**METROPOLITAN GOVERNMENT OF NASHVILLE AND DAVIDSON COUNTY**

**STAFF RECOMMENDATION**  
**1618 17<sup>th</sup> Avenue South**  
**May 15, 2013**

**Application:** Addition and New construction-outbuilding  
**District:** South Music Row Neighborhood Conservation Zoning Overlay  
**Council District:** 19  
**Map and Parcel Number:** 10408031000  
**Applicant:** Craig Clark and Amy Powell  
**Project Lead:** Robin Zeigler, robin.zeigler@nashville.gov

<p><b>Description of Project:</b> The applicant proposes to construct a rear addition and outbuilding. As part of a separate application, they also propose an office building facing Dorothy that will be connected to the house by a wall.</p> <p><b>Recommendation Summary:</b> Staff recommends approval with the conditions that:</p> <ul style="list-style-type: none"> <li>• Staff provide review of materials including: final roof color, materials for windows, doors and posts, and brick and stone samples;</li> <li>• The soffits be cement fiber rather than stucco;</li> <li>• The new brick and stone not be painted;</li> <li>• The windows within the outbuilding’s gable field be removed or replaced with a window(s) that is appropriate in proporti

① Demolition Floor Plan  
1/8" = 1'-0"

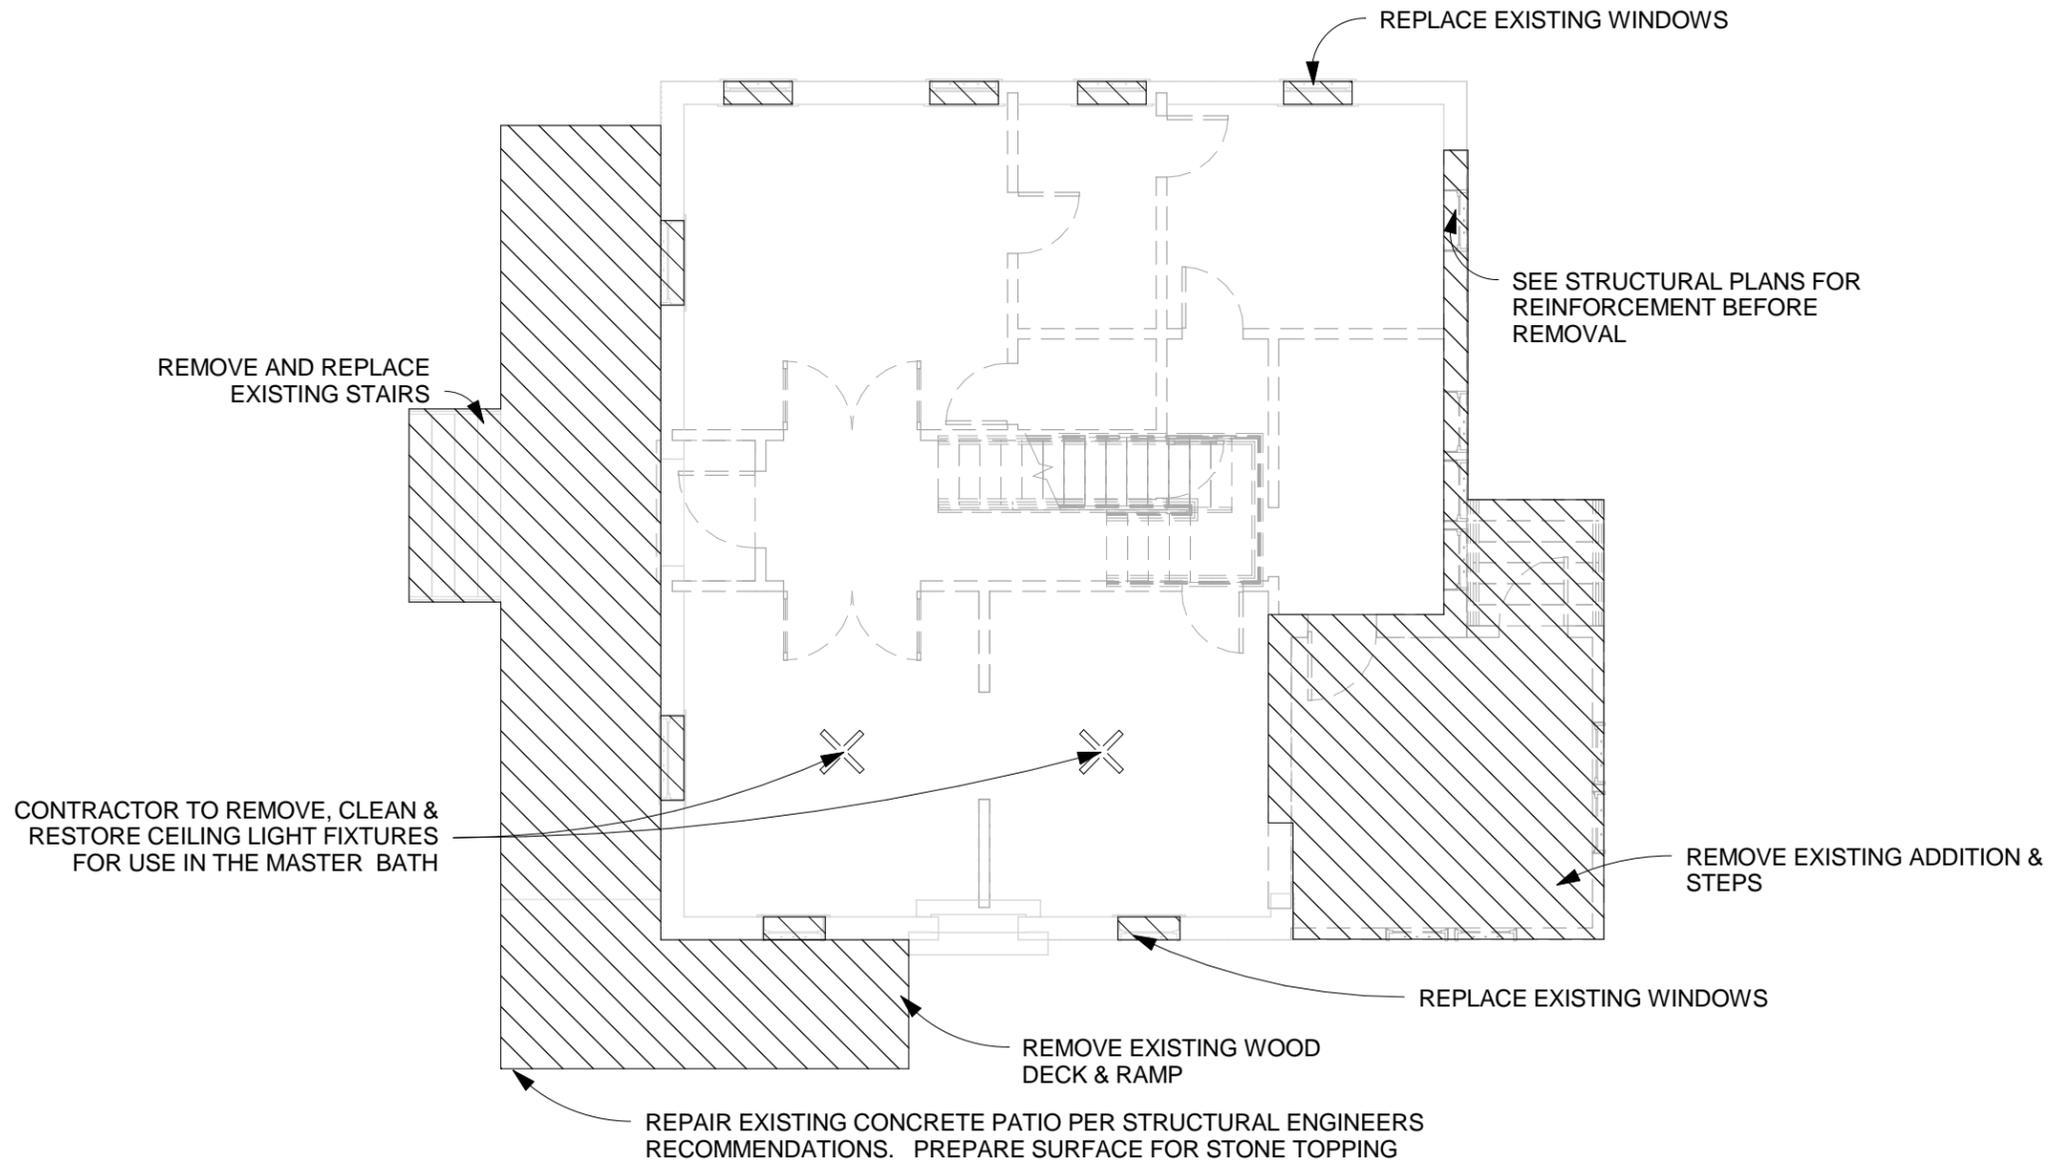
The project includes the demolition of a rear addition and a non-historic side ramp.

Staff finds demolition of these two elements to be appropriate as they are not historic and do not add to the historic character of the building. Demolition meets section II.B.2.b of the design guidelines.

1 EE - House - West  
1/8" = 1'-0"

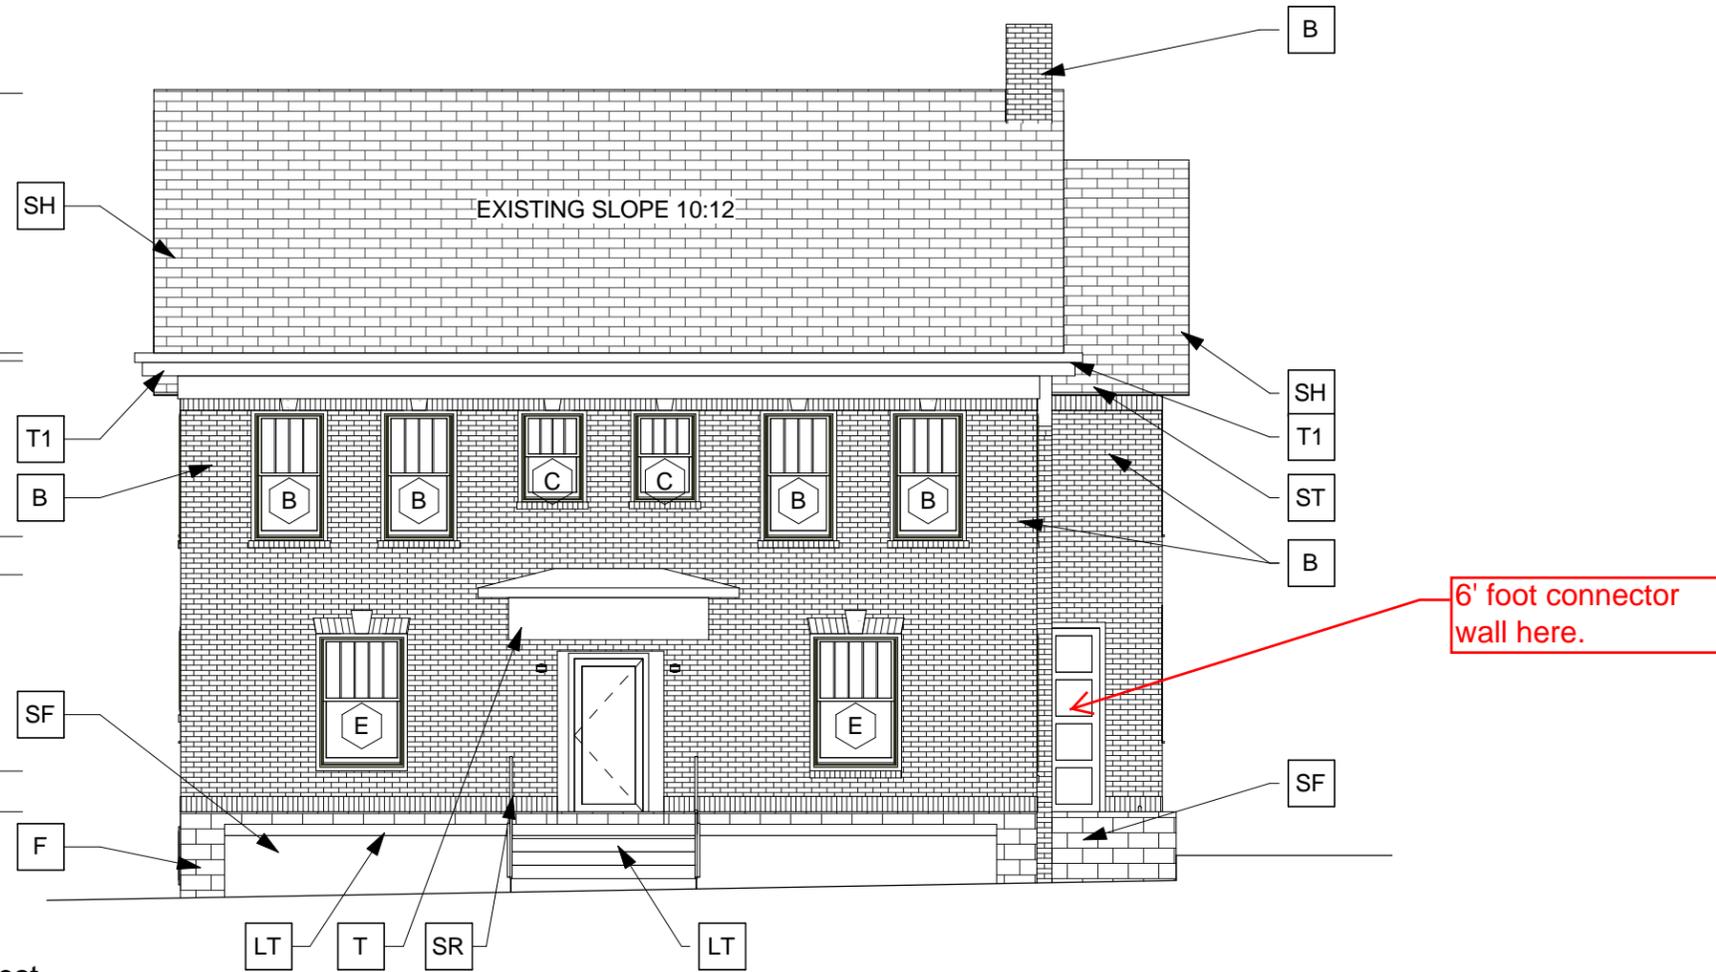
**Materials, Texture, Details, and Material Color:** The foundation of the addition and the outbuilding will be split-face arriscraft renaissance masonry, the claddings brick and the roofs asphalt shingle, color not indicated. The eave soffits are noted as stucco, which is typically not recommended by stucco manufacturers for horizontal surfaces; therefore, staff recommends a cement fiber product. The porches will be capped with limestone and railings will be stainless steel. Portions of the porch posts are metal but not all

The applicants proposes to paint the existing brick and the new brick. Although painting of existing brick is not reviewed in neighborhood conservation zoning overlays, staff advises not to paint historic brick as it will prevent the brick from wicking out water as it is designed to do. Painting of brick can cause splitting and spauling. If painted, staff advises that it should be a water-based stain, rather than paint, as it allows for the original texture to remain evident and that the color should match the color of the historic brick. The Commission does have the ability to review new masonry materials and colors; therefore Staff recommends not painting the new brick.

- Staff provide review of materials including: final roof color, materials for windows, doors and posts, and brick and stone samples;
- The soffits be cement fiber rather than stucco;
- The new brick and stone not be painted;
- The windows within the outbuilding's gable field be removed or replaced with a window(s) that is appropriate in proportion and shape; and,
- Utilities be located beyond the mid-point of the house, if a new location is required.
